# South Coast Air Quality Management District

March 20, 2018

## **Second Recirculated Draft Environmental Impact Report (RDEIR) for the Proposed West Valley Logistics Center Specific Plan (SCH No.: 2012071058)**

**Figure A: Screenshot from the AERMOD Modeling for the Proposed Project**

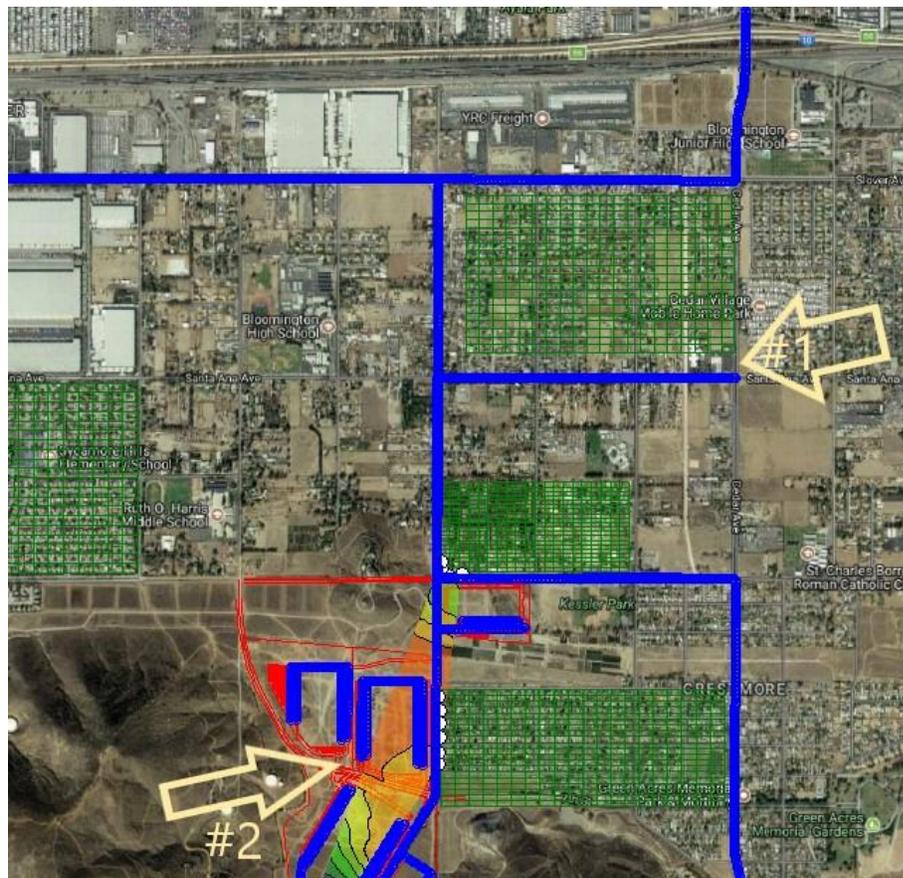
6. The truck routes were not consistent. Based on a review of Figure 3-4, *Proposed Truck Route*, in the Second RDEIR, SCAQMD staff found that trucks would travel on Cedar Avenue between Slover Avenue and Jurupa Avenue. However, in the AERMOD modeling input files for the HRA analysis, truck route stopped at Cedar Avenue, and trucks would not travel on Cedar Avenue (See #1 in Figure A below). In addition, while a new private street would be constructed to provide ingress and egress for the proposed warehouses, it was not included as part of the truck route in the AERMOD modeling input files (See #2 in Figure A below). Therefore, it is recommended that the Lead Agency clarify the truck routes in the Final EIR and, if necessary, update the HRA analysis based on one set of truck routes that is consistent throughout the document, or provide justification to explain why different truck routes should be used in the HRA analysis.

**NOTE:** truck routes are shown in blue lines in the AERMOD modeling for the Proposed Project.
